1.) There appears to be an RF connector on this device. This also is confirmed by the Internal Photos, and the Manual (item #3, page 73). Please be sure to address this issue. You are also reminded that all External Photos must show all ports and connectors to the device. Please supply an expanded set of photos showing all connections to this device. Are there provisions for connection of external antennas or coaxial cables to this product? Will the end user have access to this connector?

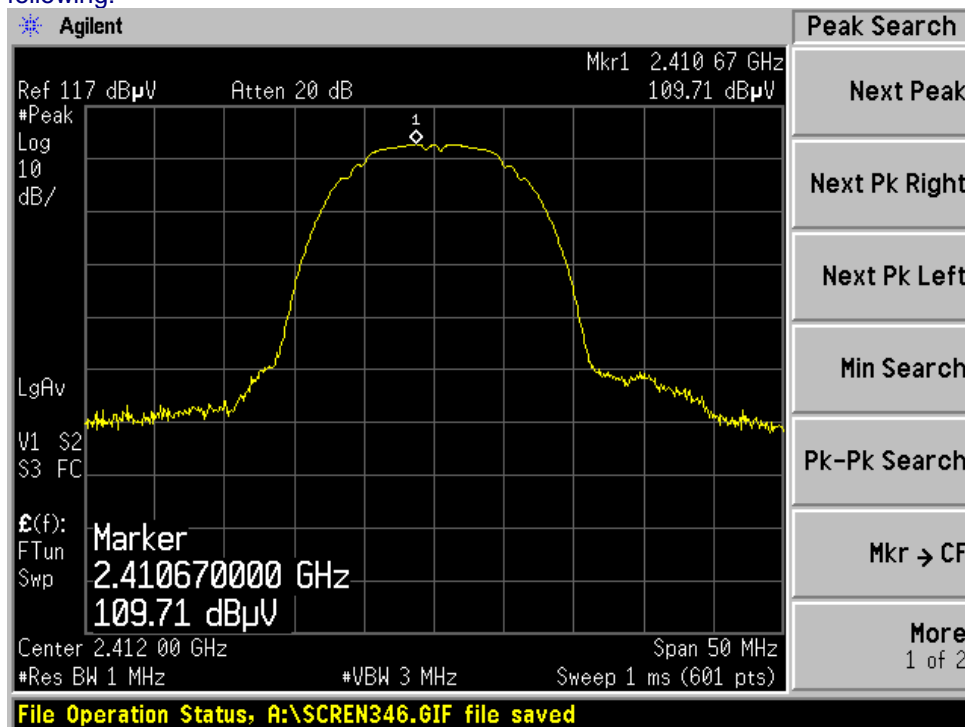
7.) The RF power measurements within the DTS report do not conform to FCC measurement procedures as described in KDB Publication No. 558074.

Reply: We retest the RF power according to the requirements of FCC Public notice, and updated the test report.
